UNITED STATES PATENT AND TRADEMARK OFFICE

Office Action Summary

10/027,203

O'BRIEN, JAMES RICHARD

Fig. 6 (Prior Art)

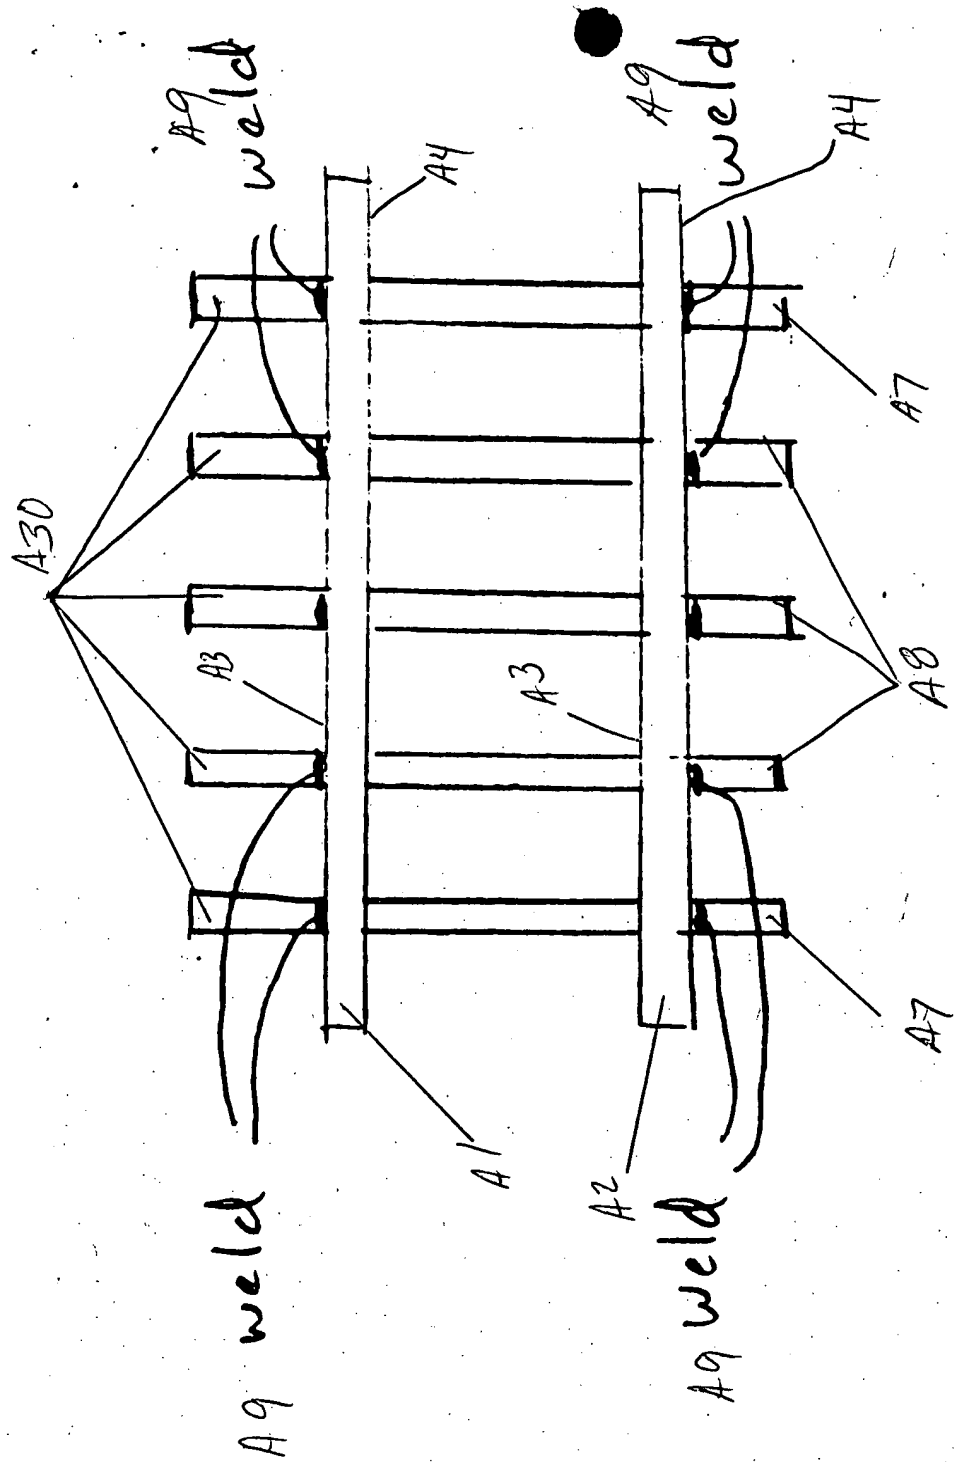
Claims 1, 10, 12-16 and 18 are rejected under 35 U.S.C. 103(a) as being unpatentable over applicant's admitted prior art (see marked-up attachment) in view of Costacurta, FR-1,061,340.

Regarding claims 1 and 12, Figure 6 of applicant's figure disclose a fence panel comprising a first rail **A1**, a second rail **A2**, spaced-apart pickets **A6**, and fasteners **A9**.

The first rail **A1** is disposed parallel and spaced-apart from the second rail **A2**. The first rail **A1** and the second rail **A2** define a longitudinal length of the fence panel,

an opposing first side edge **A3** and an opposing second side edge **A4**. The first rail **A1** and the second rail **A2** are disposed at an angle relative to horizontal.

The pickets **A6** define a pair of opposing outer pickets **A7** and inner pickets **A8**, and are disposed substantially perpendicular to horizontal. The inner pickets **A8** and the outer pickets **A7** are attached to the first rail **A1** and the second rail **A2**.

The fasteners **A9** are between the inner pickets **A8** and the first side edge **A3** of the first rail **A1** and between the inner pickets **A8** and the second side edge **A4** of the second rail **A2**.

However, the prior art fails to disclose the fasteners **A9** between the outer pickets **A7** and the second side edge **A4** of the first rail **A1** and between the outer pickets **A7** and the first side edge **15,16** of the second rail **26**. The French patent '340 teaches fasteners between the outer pickets **C** and a second side edge of a first rail **A** and between a first side edge of a second rail to fasten the outer pickets to the rails at intersections. Therefore, as taught by the French patent, it would have been obvious to one of ordinary skill in the art at the time the invention was made to include fasteners between the outer pickets and the second side edge of a first rail and the first side edge of the second rail to fasten the pickets to the rails.

Regarding claims 10 and 18, Figure 6 of applicant's figures shows the first rail **A1** and the second rail **A2** are four-wall tubular members.
